CITY PLAN COMMISSION STAFF REPORT

Project Name
Kiddie Academy

CD-CPC-2024-00002
Development Plan – Major Amendment

The applicant is seeking approval of a major amendment to a previously approved development plan, which also serves as a preliminary plat, to allow the construction of a 13,000 square foot day care center in district B2-2 on about 1.5 acres generally located at 9880 N Cedar Avenue.

PRELIMINARY PLAT OF HIGHLAND PLAZA WEST 2ND PLAT, LOTS 1 & 2 A SUBDIVISION IN KANSAS CITY, CLAY COUNTY, MISSOURI

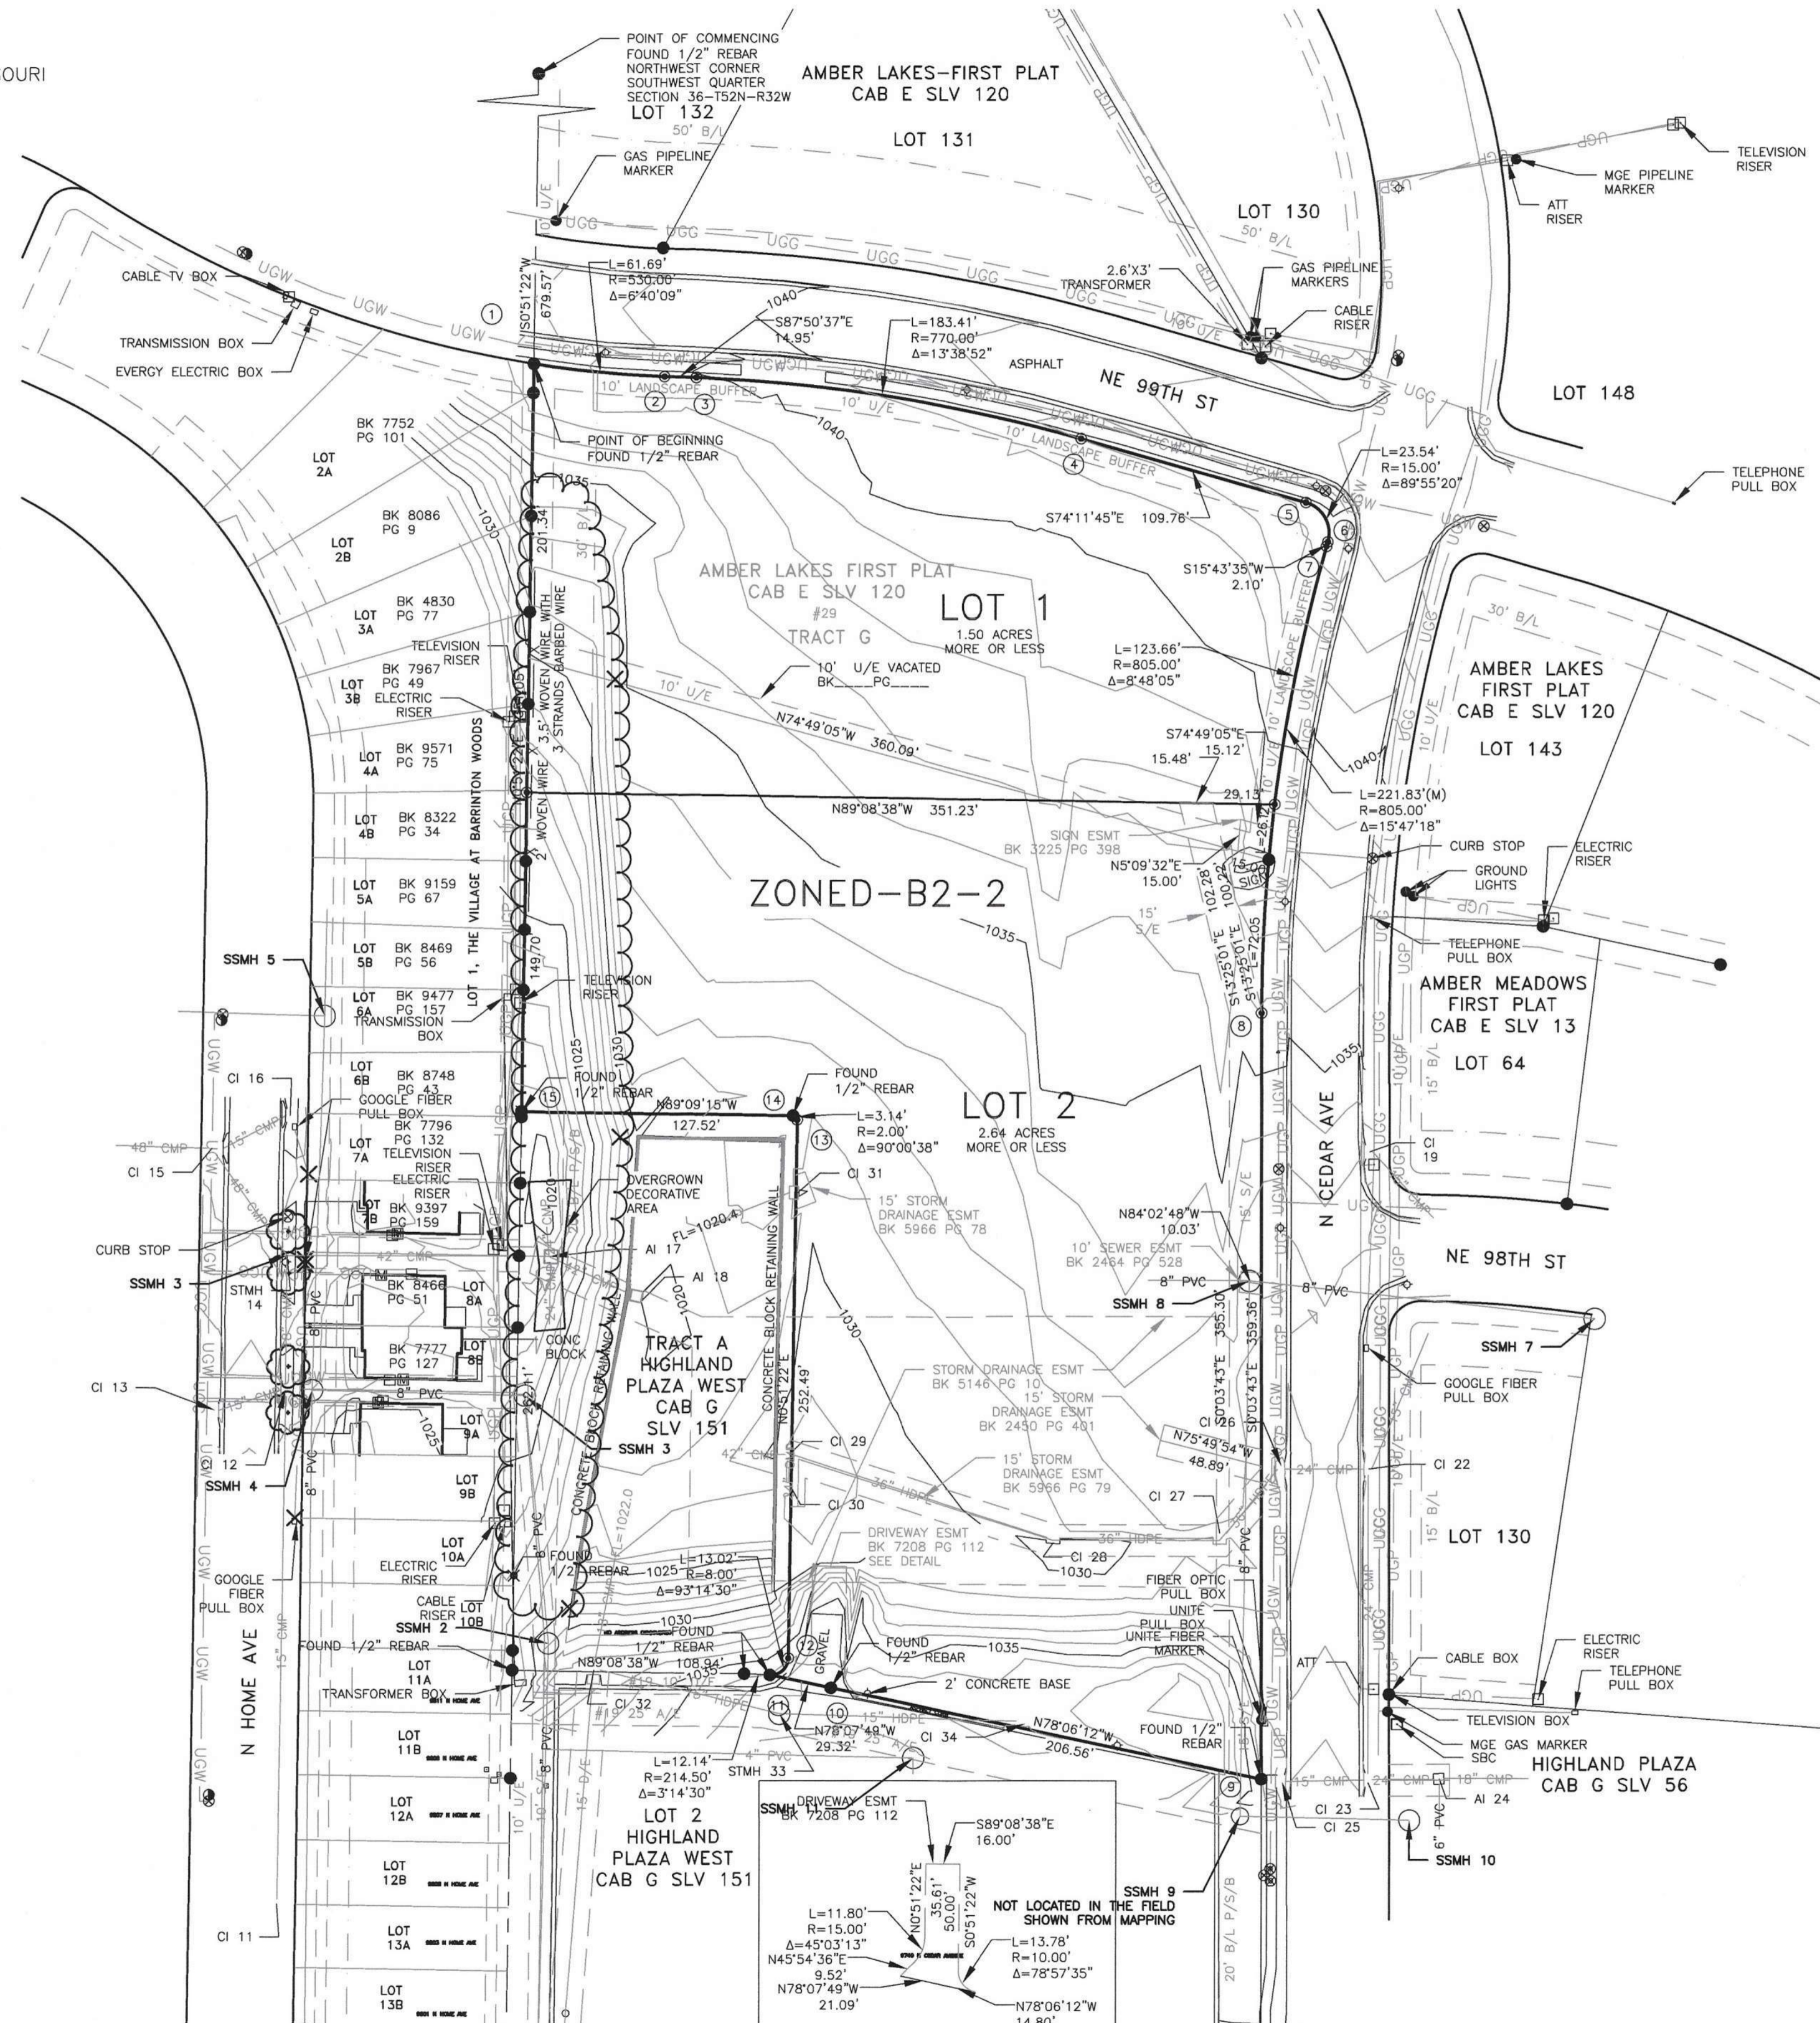
- The applicant needed more time to prepare the preliminary plat sheet to show the sanitary sewer extension needed to serve the site.

Sanitary sewer extension in N 99th Street is required to serve the site, which is shown on the preliminary plat associated with the development plan. The site is adequately served with water.
